City of Richmond

Report to Council

To: Richmond City Council **Date:** July 19, 2006
From: Councillor Harold Steves **File:**
Chair, Planning Committee
Re: **Application by Rize Alliance (Richmond I) Properties Ltd. for Rezoning at 8080 and 8084 Granville Avenue and 7080 No. 3 Road from Automobile-Oriented Commercial District (C6) and Downtown Commercial District (C7) to Comprehensive Development District (CD/176)**

RZ 05-317472

Figure 1. Aerial photo of subject property - from the City of Richmond's online mapping and GIS website – <http://www.richmond.ca/discover/maps.htm>

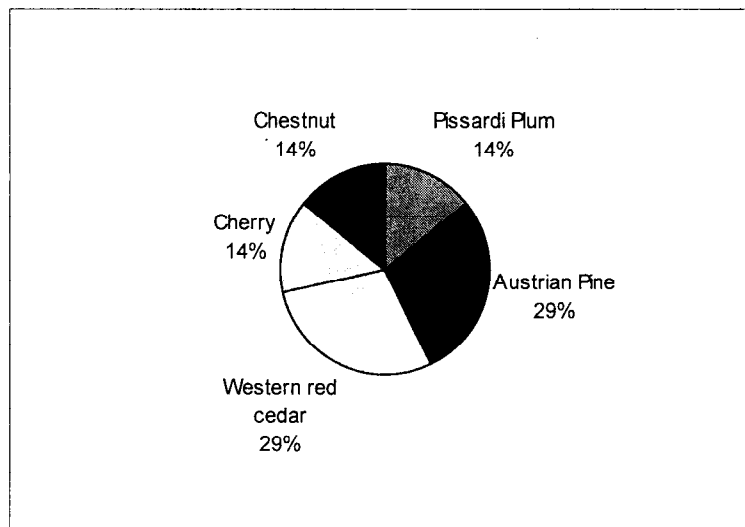
The site is comprised of a large, flat, commercial lot. At the time of the arboricultural field work, there were no trees located on the lot and site preparation had already begun. An aerial photo of the site (**see Figure 1**) shows that no trees existed on the site prior to site preparation either. There are 7 trees located on city property and neighbouring lots that encroach onto the subject property, or could potentially be impacted by the development.

APPENDIX 3 - TREE PROTECTION FENCING DETAIL

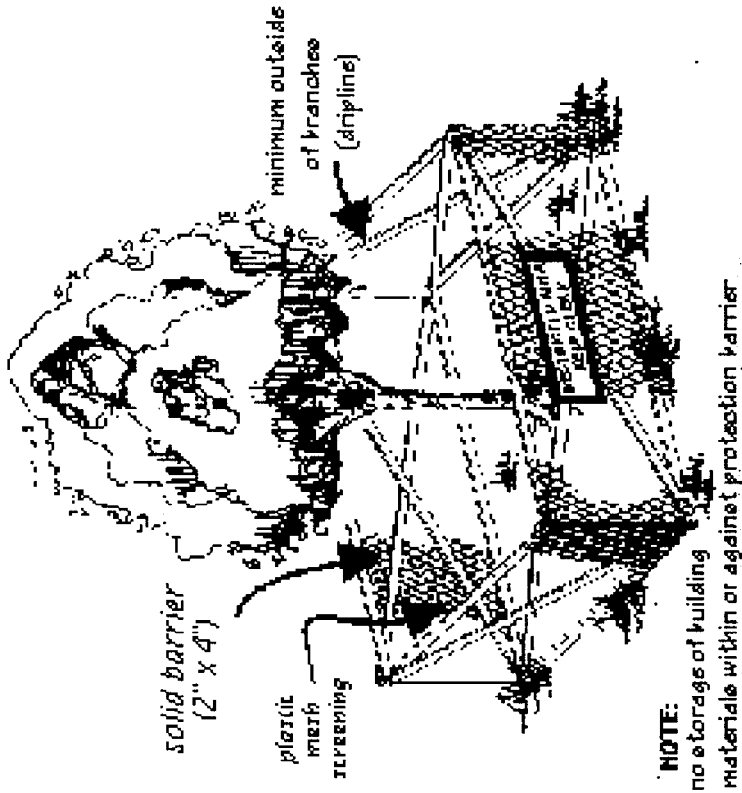
The Chestnut tree (number 7) located on the boulevard of Granville Avenue will require tree protection fencing constructed as indicated in the Tree Protection Fencing Detail (**Appendix 3**). The location of the fencing is shown in the Tree Protection Plan (**Appendix 2**).

The tree protection fencing must be constructed of either **1.2m snow fencing** securely fastened to a (minimum) 2" x 4" wood frame with cross braces or **plywood** nailed to 2" x 4" wood stakes and weatherproof signage every 50m, or less, reading "Tree Protection Area, Keep Out". It is further recommended that the Tree Protection Fencing be located no less than 2 meters outside the dripline.
